Technical bulletin

HD1200 - HD1200E

Battery charger for radio kit

148

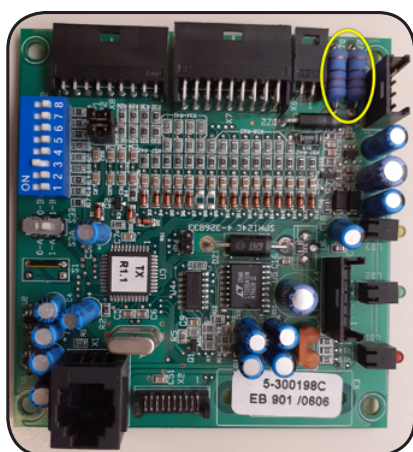
This note is required due to a change in the electronic board created in 2016. Match the correct battery charger based on the new resistors installed.

This change can be quickly recognised as follows:

Board before 2016: requires battery charger with code **4-328832**

Board from 2016: requires battery charger with code **4-330050D**

We would like to inform you that if you need to replace the battery charger of the radio kit on the above-mentioned machines manufactured before 2016, the code required is 4-328832. Serial numbers of machines up to CLNxxxxxx.

On machines manufactured from 2016 to the present day (serial no. CMAxxxxxx onwards), the code of the battery charger to be ordered is 4-330050D.
